GAO

NAVY SHIPS

Problems Continue to Plague the Seawolf Submarine Program

B-250714

Figure 2.2: Comparison of Scheduled to Actual Workers Constructing the SSN-21

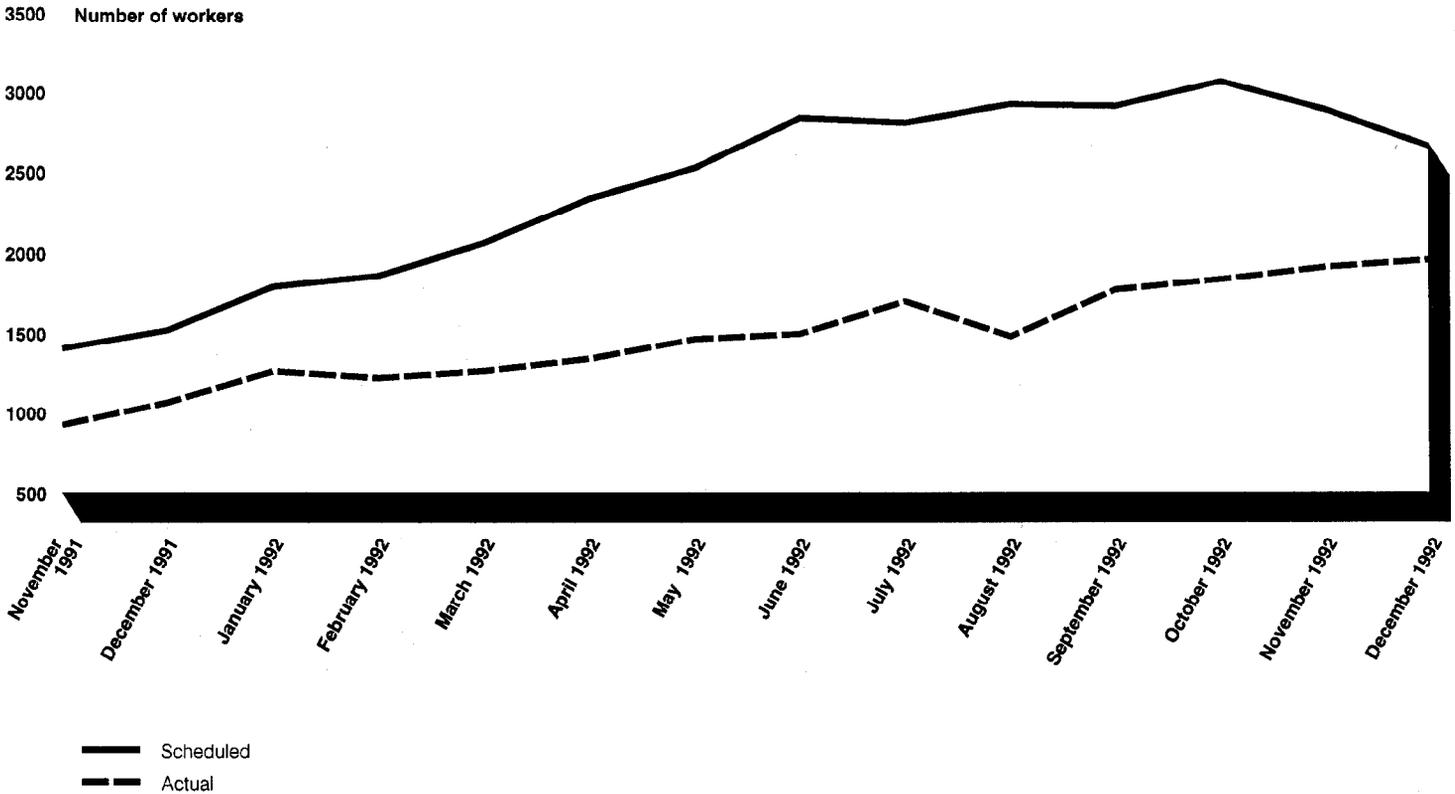
The size of the SSN-21 construction work force has consistently been smaller than planned under the Revision E construction schedule and has caused less work to be performed. Since November 1991 (when the Revision E construction schedule was approved) through December 1992, the understaffing percentages have ranged between a high of 49 percent (August 1992) and a low of 26 percent (December 1992), for an average of 38 percent over this period. (See fig. 2.2.)

Since as early as June 1992, the Navy has been concerned with the construction work force's size. In addition to informing Electric Boat of its concerns during regular meetings, program documentation shows that the Navy has continually requested Electric Boat to discuss differences between planned and actual construction work force levels, the reasons for not meeting planned levels, and planned corrective actions to ensure the SSN-21 is delivered on schedule. Subsequently, in October 1992, after several meetings with Electric Boat officials, the Navy's Supervisor of Shipbuilding concluded in a letter to Electric Boat that (1) since May 1992, all staffing recovery commitments have fallen well short of stopping schedule delays, let alone recovering from schedule delinquencies, and (2) the SSN-21 would not be delivered on schedule if the shipbuilder continued to understaff construction.

DOD RESPONSE: Partially concur. Factors affecting the level of manning of SSN-21 construction, beyond the availability of design data, include (1) material availability, (2) work package procedures, and (3) manning of other ships under construction. There are sufficient personnel available to complete the ship on schedule.

Figure 3.1: Comparison of Original SSN-21 Design Target Cost to Estimate-at-Completion (Current-Year Dollars)

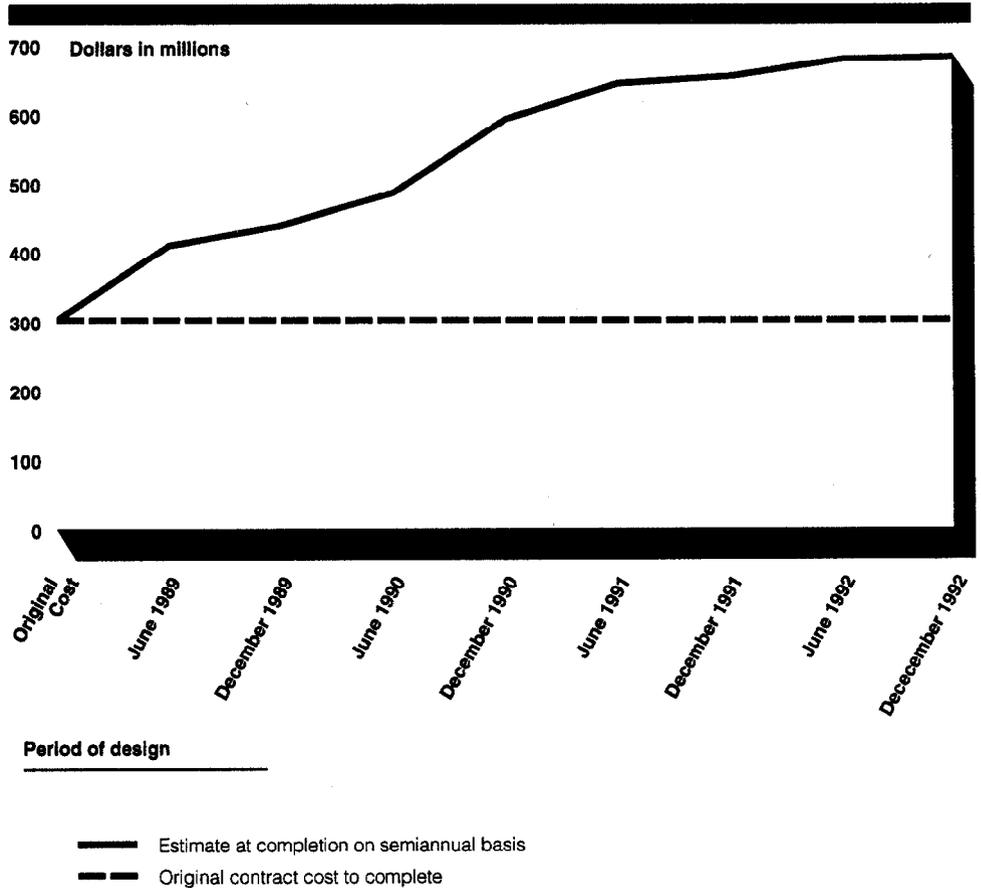
In commenting on this report, DOD stated that the SSN-21 program office baselined the detail design contract on June 20, 1990, and, as a result, the comparisons used in this report do not represent the current contractual agreement with Newport News Shipbuilding. Relative to the rebaselined contract, the current estimated cost of \$649.5 million (current-year dollars) represents a 22-percent increase.

While we recognize that subsequent events often require that changes be made to contracts and related estimates, we believe that comparing current cost estimates to the original cost estimates provides an insight into the events that are influencing the program and the trend of the program.

The draft report consistently compares the latest revised contractor estimate to the original basic contract. Such a comparison does not adequately reflect the fact that the SEAWOLF Program Manager rebaselined the detail design contract on June 20, 1990. As a result, the comparisons in the draft report are not representative of the current contractual agreement with the lead design yard. Relative to the rebaselined contract, the current estimated cost of \$649.5 million (current year dollars) represents an increase of 22 percent.

Figure 3.2: Comparison of Original SSN-21 Construction Target Cost to Estimate-at-Completion (Then-Year Dollars)

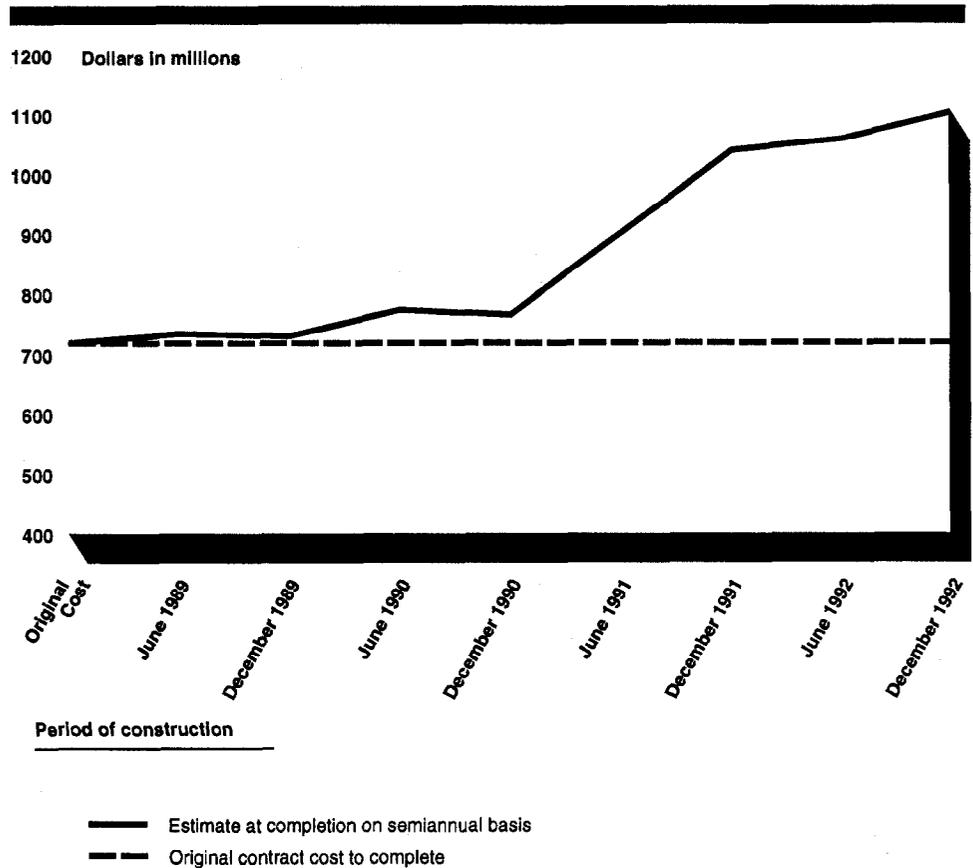
The \$64-million increase since December 1991 consists of \$15 million for contract changes, \$30 million for increased labor rates, and \$19 million for increases in material cost estimates at completion. Table 3.1 shows the major factors contributing to the \$385-million increase.

DOD RESPONSE: Partially concur. The draft report incorrectly compares the initial contract target price (not adjusted for inflation), with the current contractor estimate. In order to calculate percentage cost increases a common year for all dollar figures must be used to add or subtract inflation related differences. The \$718 million is not adjusted for inflation. A more accurate comparison is to compare the \$718 million (1987 dollars) with \$974.7 million (\$1,103 million adjusted to 1987 dollars), which is an increase of \$256.7 million (35 percent) over the original contract target price and a \$32 million (3.3 percent) increase from December 1991. Over half the 35 percent growth is due to the cancellation of the outyear SEAWOLF submarines and the impact of Stop Work Orders.
